9.5 Other Auxiliary Systems

The information in this section of the reference ABWR DCD, including all subsections, tables, and figures, as modified by the STP Nuclear Operating Company Application to Amend the Design Certification rule for the U.S. Advanced Boiling Water Reactor (ABWR), "ABWR STP Aircraft Impact Assessment (AIA) Amendment Revision 3," dated September 23, 2010 is incorporated by reference with the following departures and supplements.

Figure 9.5-2 Outline - Telephonic Communication System for Single Unit of STP 3 or 4

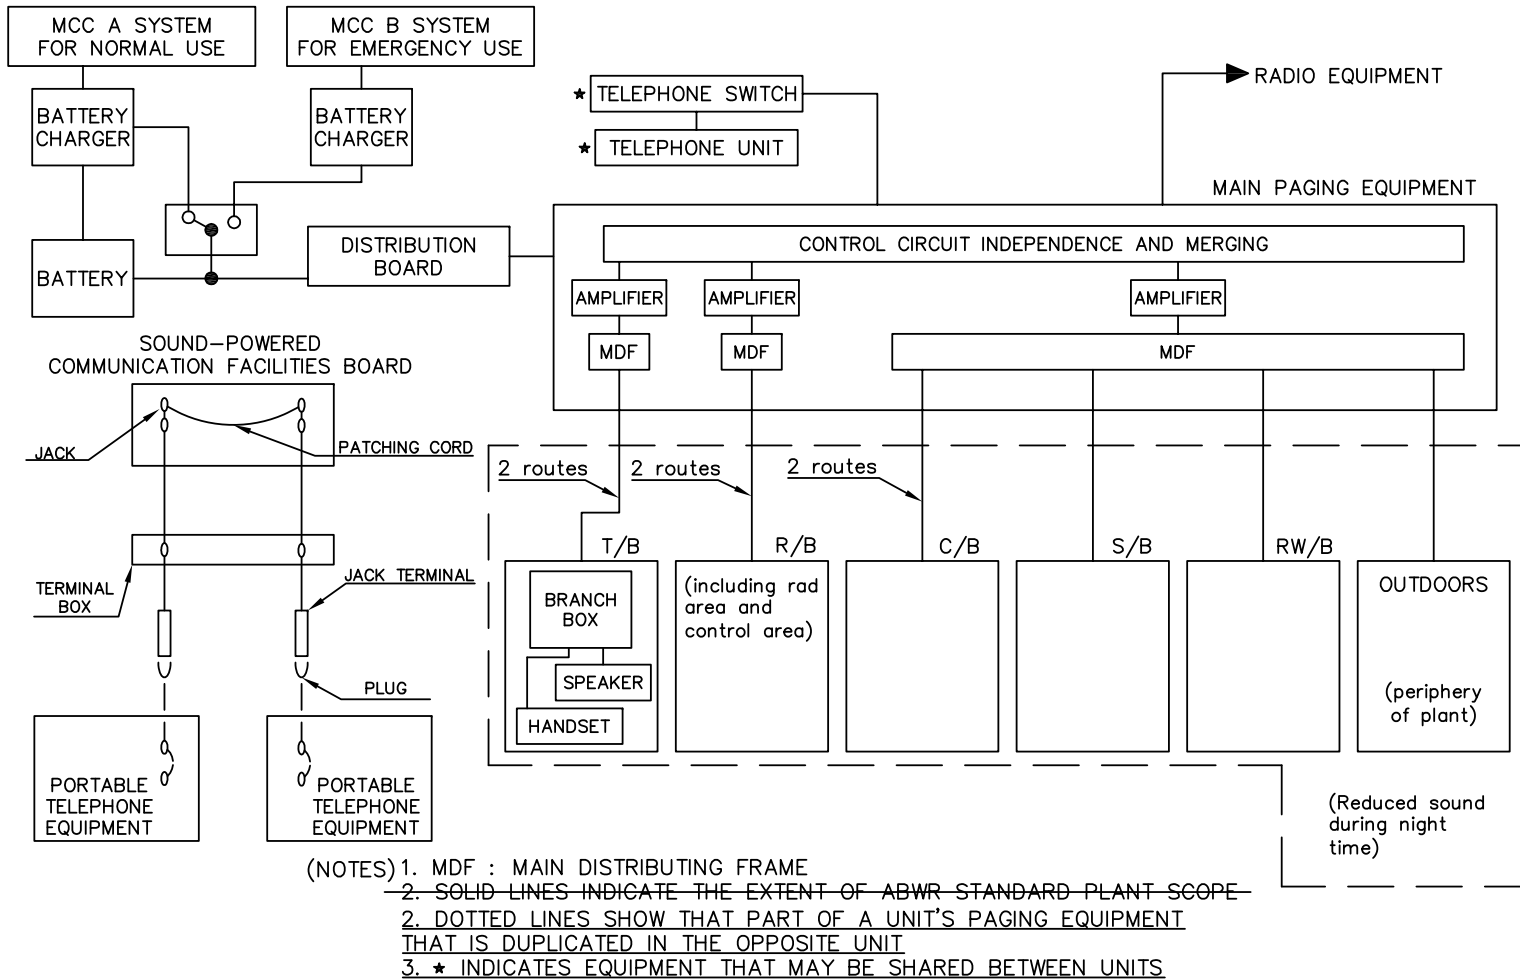
| STP DEP 1.1-2 (Figures 9.5-2, 9.5-4 and 9.5-5) | STD DEP 9.5-3 |

At STP 3 & 4, a common communication system is used to provide plant-wide communications between the dual units. The communication system is not safety-related. A common communication system providing plant wide communications is a safety enhancement since it allows for ease of communication between units. The representative outline of the common communication system is shown in Figure 9.5-2 for STP 3 & 4.

Figure 9.5-3 Lower Drywell Flooder System Arrangement/Configuration

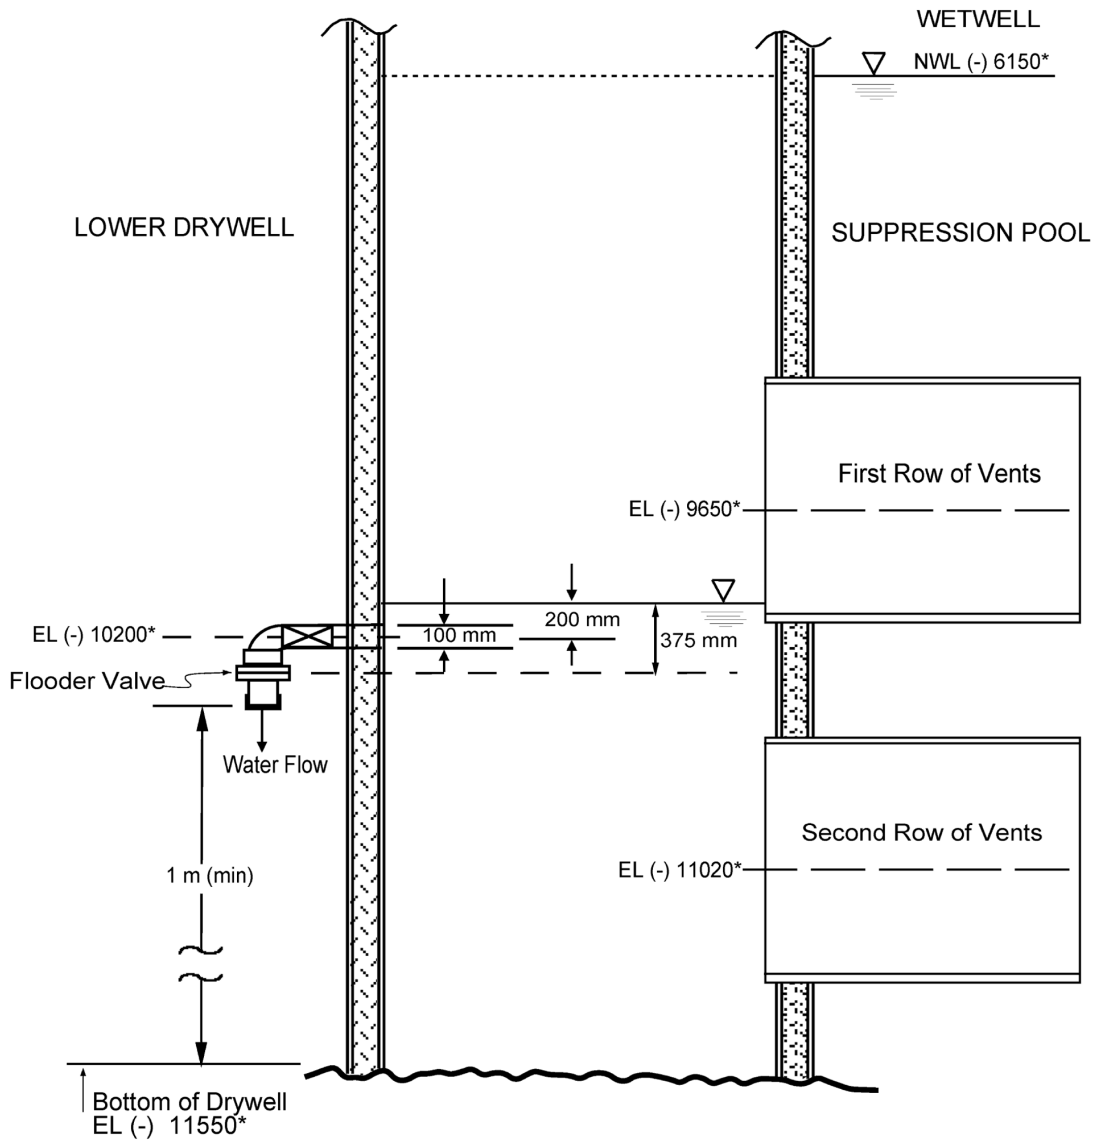
| STD DEP T1 3.4-1 | STD DEP 9.5-2 (Figure 9.5-3, replaced entire figure) |

The LDF, shown schematically in Figure 9.5-3, provides a flow path for suppression pool water into the lower drywell area during severe accident scenario that leads to core meltdown, vessel failure, and deposition of molten corium on the lower drywell floor. Molten corium is a molten mixture of fuel, reactor internals, the vessel bottom head and control rod drive components. The flow path is opened when the lower drywell airspace temperature reaches 260°C.

The LDF consists of ten pipes that run from the vertical pedestal vents into the lower drywell. Each pipe ~~contains~~ has an isolation valve and a fusible plug valve connected to the end of the pipe that extends into the lower drywell ~~by a flange~~. The fusible plug valves open when the drywell air space ~~(and subsequently the fusible plug)~~ temperature reaches 260°C. When the fusible plug valves open, a minimum of 10.5 L/s of suppression pool water will be supplied through each flooder pipe (105 L/s total) to the lower drywell to quench the corium, flood the lower drywell and remove corium decay heat, which is estimated at 1% of rated thermal power. The flow rate is based on a minimum hydrostatic head of 200 mm above the flooder pipe inlet centerline and takes the frictional losses through the flooder pipe and fusible plug valve into account.

Figure 9.5-4 Fire Protection Water Supply System

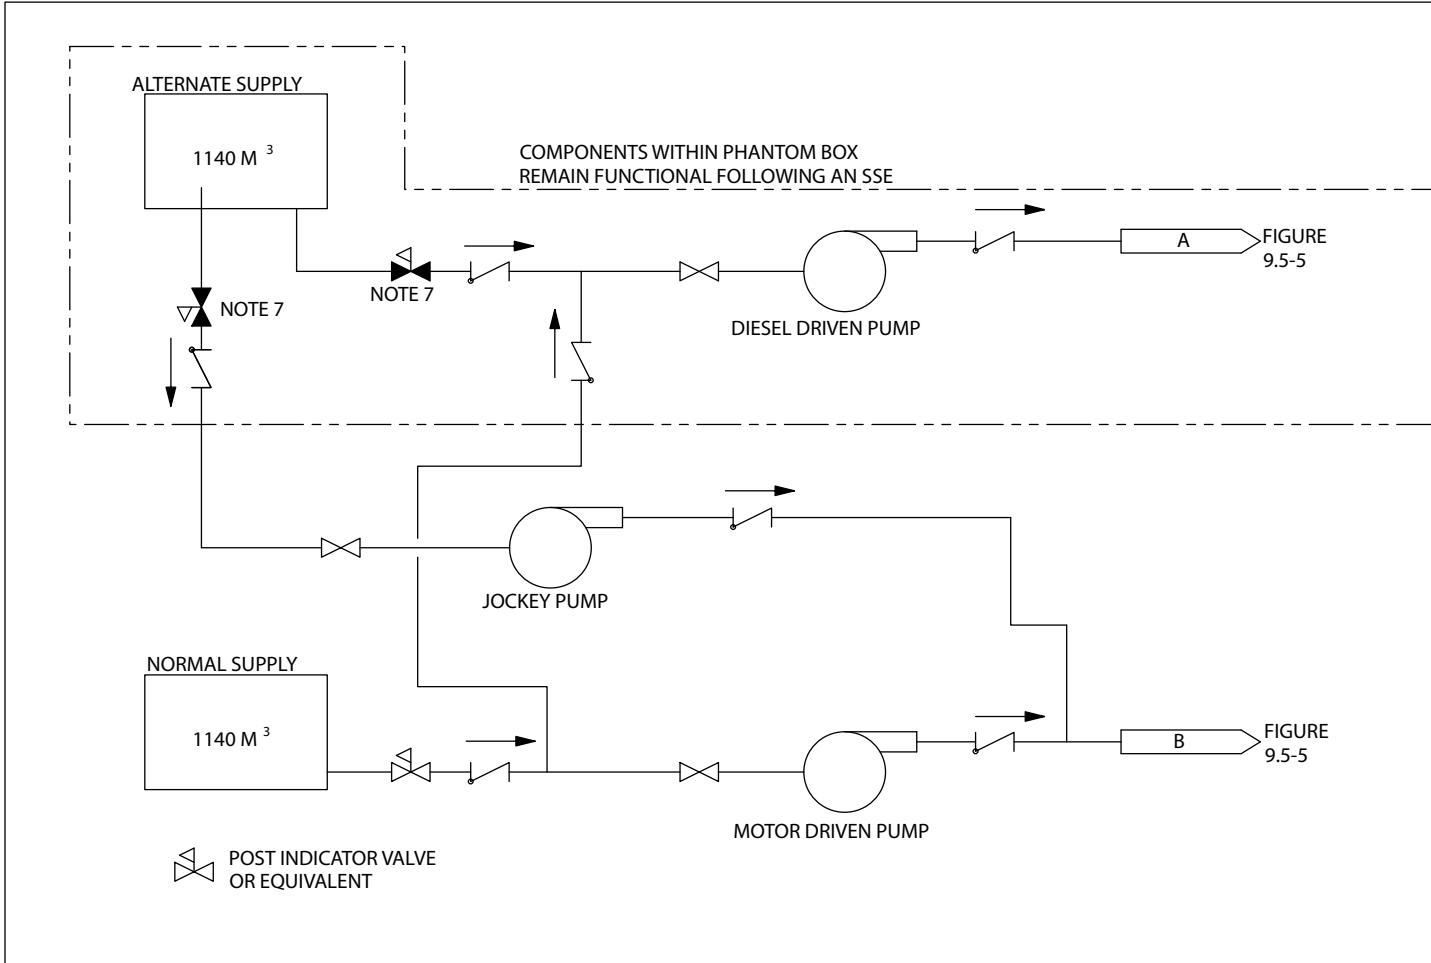
STP 3 & 4 is a dual-unit station. The water supply for fire protection will be shared by STP 3 & 4. A single fire protection pump house and two storage tanks are located within the protected area boundary that provides water for fire suppression to both units via piping in the yard. This common system has the same capability as the system for the single unit design. The fire protection water supply complies with Regulatory Guide 1.189, Rev. 1, which states that a common water supply may be utilized for multi-unit nuclear power plant sites with a common yard fire main loop. The common fire water supply and yard main piping system for STP Units 3 & 4 are depicted in Figures 9.5-4 and 9.5-5. The common yard fire main loop surrounding STP Units 3 & 4 is cross-connected between units in accordance with Regulatory Guide 1.189, Rev. 1.

Figure 9.5-5 Fire Protection Yard Main Piping

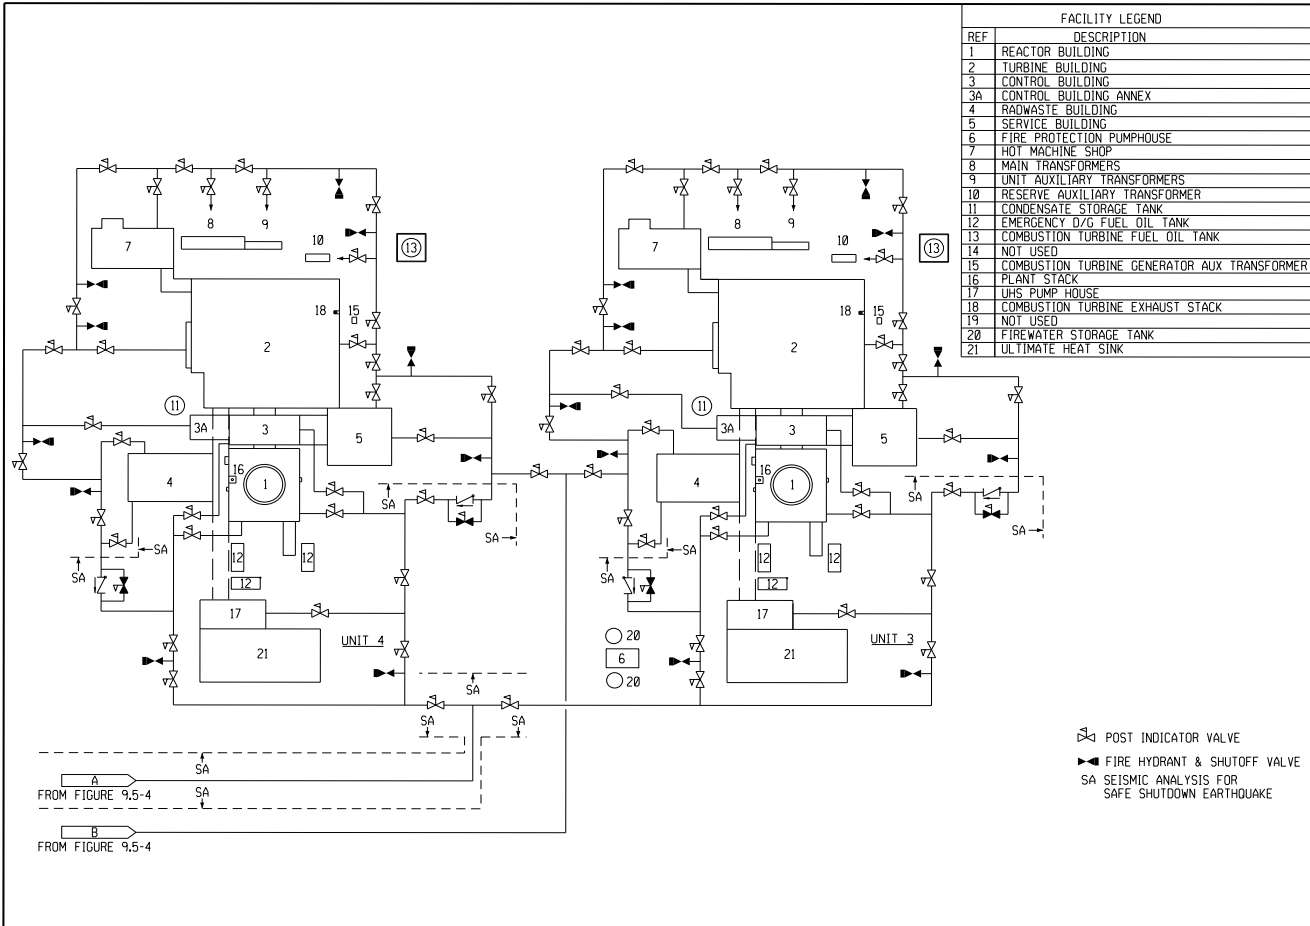
| <i>Area</i> | <i>Figures</i> |
|--------------------------|---|
| <i>Plant Yard</i> | <i>9.5-5</i> |
